Our Ref: R/2016/1/J
File No: 2022/298034
Your Ref: MP08_0098-Mod-18

**Advice on Modification
Star Casino – MP08_0098 Modification 18 – Alterations and Additions to Multi-Use Entertainment Facility**

Figure 1: Proposed section, with extent of additional bulk around the fly tower outlined in red

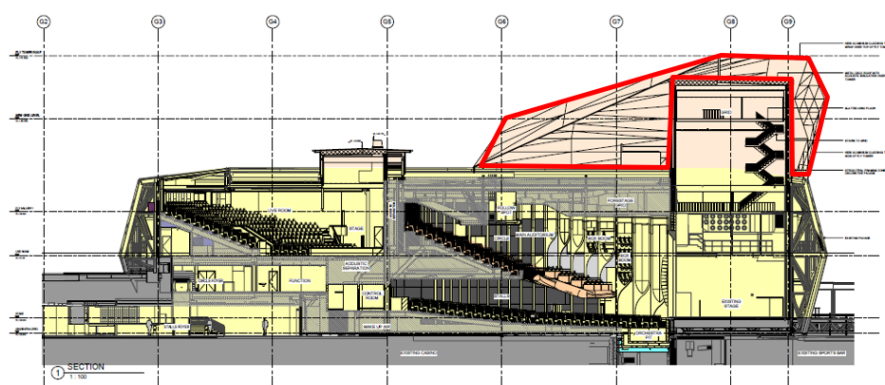
Concern is particularly raised on the extent of additional bulk proposed around the fly tower. As outlined above, it is acknowledged that the proposed fly tower is required to house these types of theatre productions. However, it is not clear why the area adjacent to the fly tower, as shown in the section below, requires this extent of additional bulk. These additions result in devastating view loss impacts and the bulk should be reconsidered and minimised in size as much as possible.

Figure 2: Proposed western elevation, with plant room outlined in red

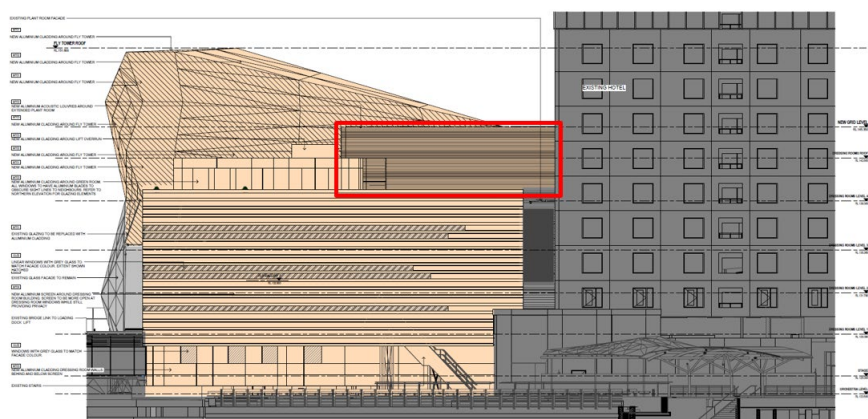
There is also an extensive plant area on the roof of the dressing room building that leads to significant bulk impacts. The services should be relocated to reduce the view loss that results from these additions.

Figure 3: Excerpt from Visual Impact Assessment, with 'likely future view' and 'area of impact' diagrams shown. Note that the 'area of impact' diagram does not show the 5 storey dressing room and plant additions.

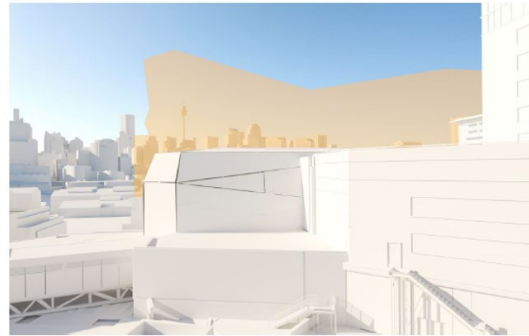
The 'area of impact' figures do not include the new 5 storey dressing room addition with additional plant room, which significantly increase the visual impact on almost all the camera views. When viewed in isolation, as is the case in the Summary of Impacts in Section 7.4, the 'area of impact' images do not fully depict the proposed bulk of the development. The summary should show the area of impact combined with all of the additional bulk proposed, incorporating the fly tower, rigging loft as well as the dressing room addition. Not including all the impacts in the summary makes it difficult for the community to understand the impacts of the proposal and therefore make informed submissions.
